DIABLO CANYON UNIT 1 DESIGN
VERIFICATION PROGRAM - SEISMIC
ANALYSIS OF BURIED TANKS

Date: Wednesday, July 6, 1983

MEETING WITH NRC
ON BURIED FUEL TANKS

MESH A
(1978 & 1982)

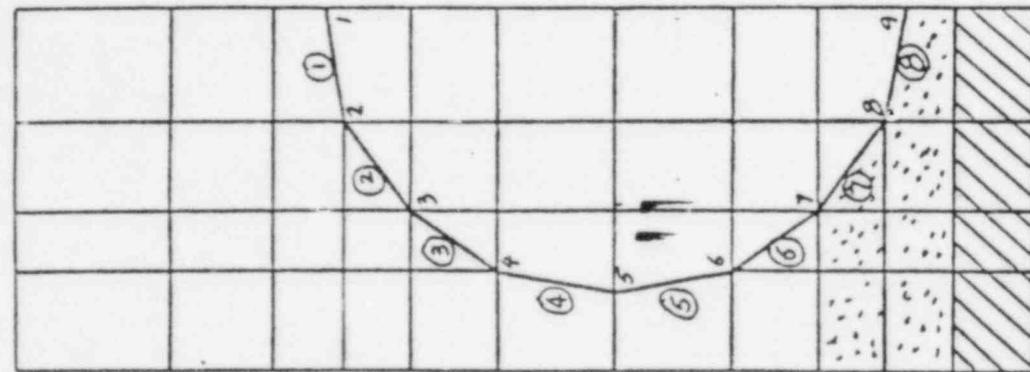
11 MR. MILLER: We will show some results in a
12 while that indicate that in fact what I am saying is
13 exactly true, you are trading one error for another error,
14 and Mesh A is grossly an inappropriate mesh even though it
15 may turn out that the tank is still fine.

20 MR. MILLER: I would also like to make a comment
21 to follow up on what I said before. These data indicate
22 that in fact Mesh A gives results that nothing like even
23 Mesh B or Mesh C. Certainly these data do not support the
24 fact that Mesh A is a reasonable mesh to do the problem.

12 MR. CONSTANTINO: The thing we said two weeks
13 ago was that we felt Mesh A, which is all we were looking
14 at, was an incorrect mesh to use. It turns out we are
15 right, and the bit about qualification really is not our
16 problem. We said last time and we say now that the mesh
17 data that was presented to us was an improper way to
18 perform the analysis and that was our only comment and I
19 think you will see the result Mike presents will show that
20 to you.

16 MR. REICH: Well, "A" is something we spoke about
17 in great detail. I think we showed that it does not transmit,
18 really, what is happening in reality. Those elements cannot
19 move, so therefore you have a situation which is not real.

Factors of Safety Against Yielding at Outer Fiber

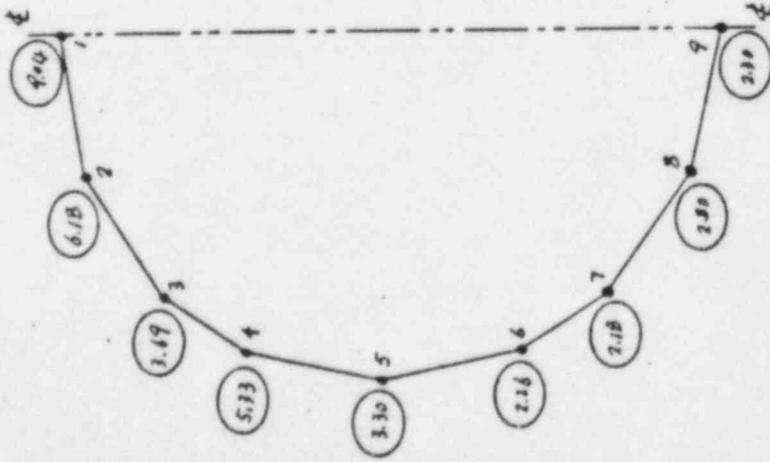
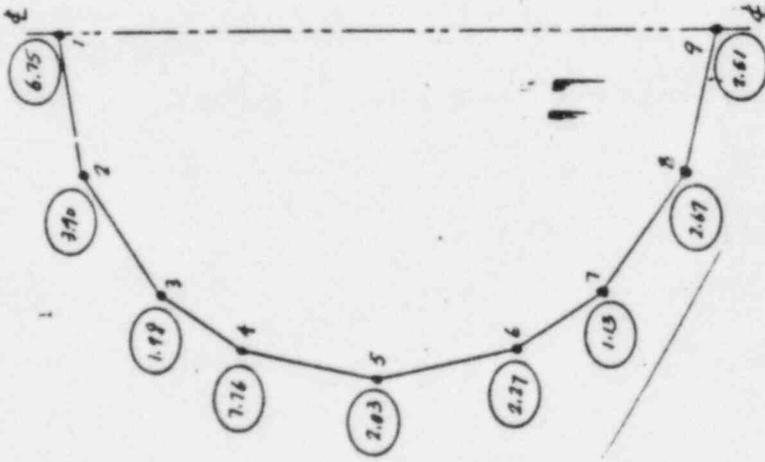
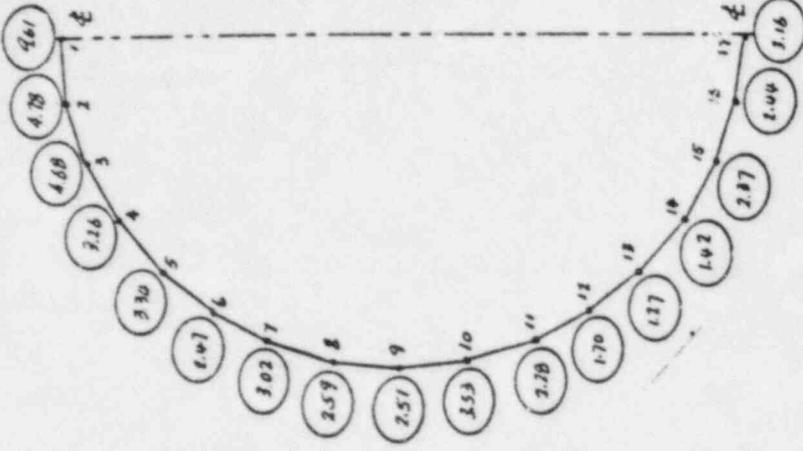
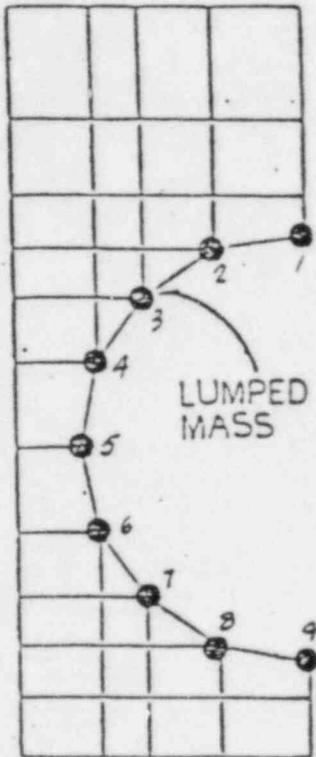
9 MR. REICH: I have one question which I want to
10 clarify. Your mesh now in the Figure 8 is really a new
11 analysis because you use different types of safety
12 factors, different types of material properties. You have
13 just told us that, am I correct?

15 MR. REICH: So that is not the same one you sent
16 us. I just want to clarify that. The thing that you sent
17 us in the mail, the report from Harding and Lawson which
18 we received, the 1982 report, and not 1980 as was
19 mentioned previously, did not have these properties. You
20 just now took different properties?

19 MR. SCHIERLING: Do you have the same
20 information, and someone raised the question before, but
21 do you have the same information without the mill cert
22 data so that you can go and compare the BNL analysis and
23 your analysis both based on the same information?

5 MR. WHITE: Yes. What we wanted to do was
6 provide the results from Mesh A, B and C all on a common
7 basis. That was the reason for redoing the safety factors
8 associated with Mesh A.

3 MR. HOCH: Let me point out, Hans, the
4 interested reader can ratio the two allowables and correct
5 the safety factors or change them as he sees fit. We
6 didn't provide the numbers, but it is easy for someone who
7 is interested to reconstruct that number.

HLA MODEL

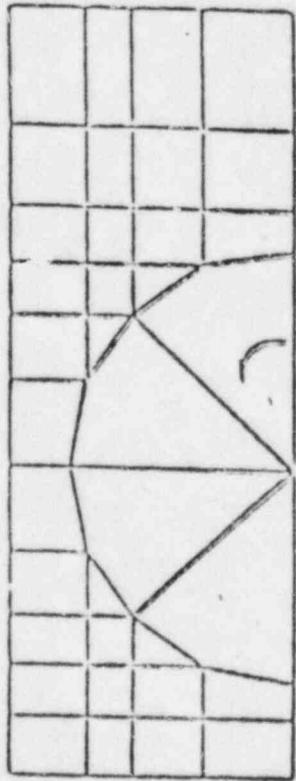
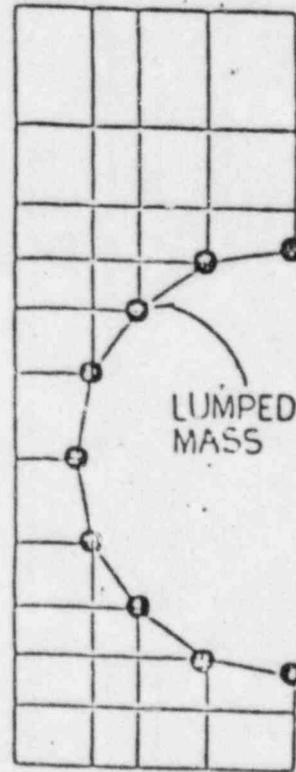
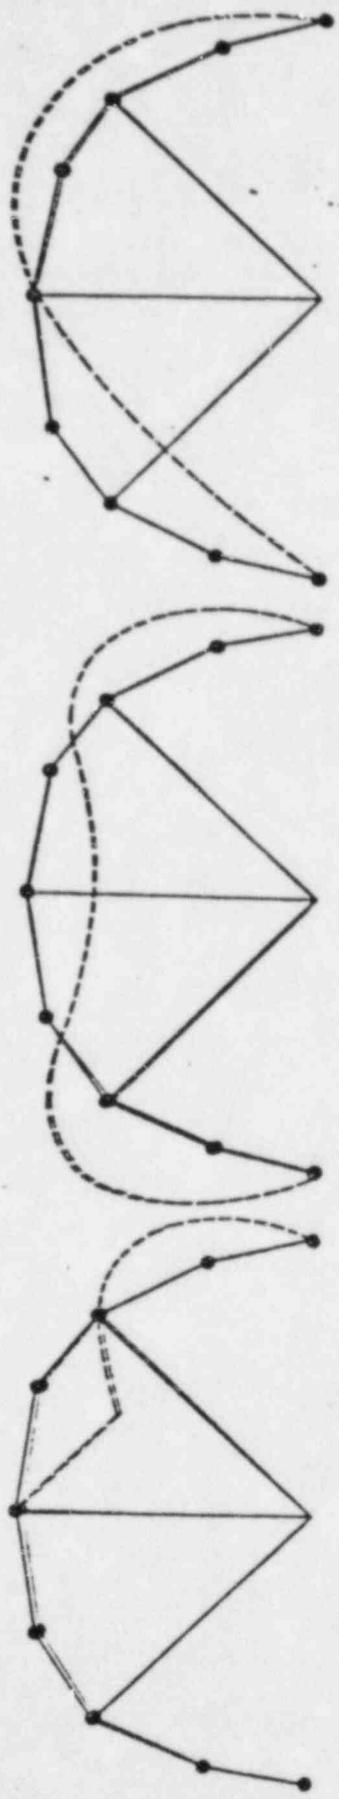
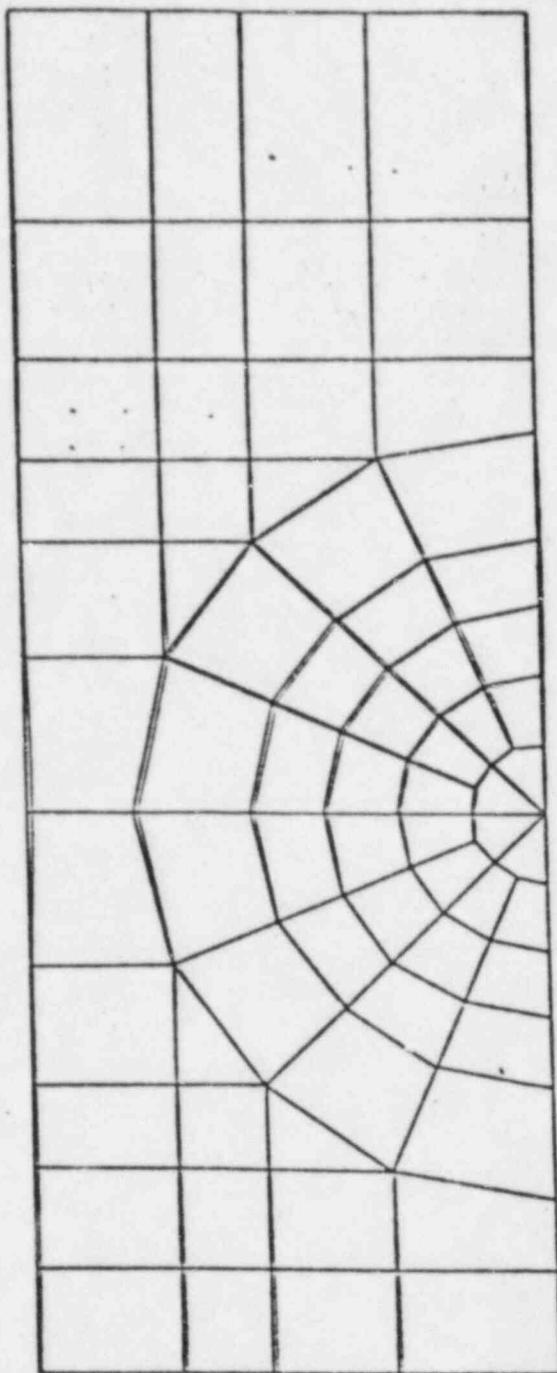
15 So what that model does is it basically
16 eliminates this kind of a mode or response. That is why,
17 as Mike suggested before, what happens when you eliminate
18 this is you eliminate the bending and because you are now
19 putting the fluid in compression and tension, now you are
20 putting a big axial force on.

10 MR. PHILIPPACOPOULOS: In other words, this is a
11 very significant mode for calculating the response in your
12 tank, asnd in the HLA model this kind of mode cannot exist
13 with this kind of modeling of the fluid element. That is
14 our point.

2 MR. HOCH: I would like to ask a question, and I
3 am sorry to jump in. Could you characterize the HLA model
4 as shown up here, the very simplified model, one could
5 characterize it as being conservative with respect to
6 axial force.
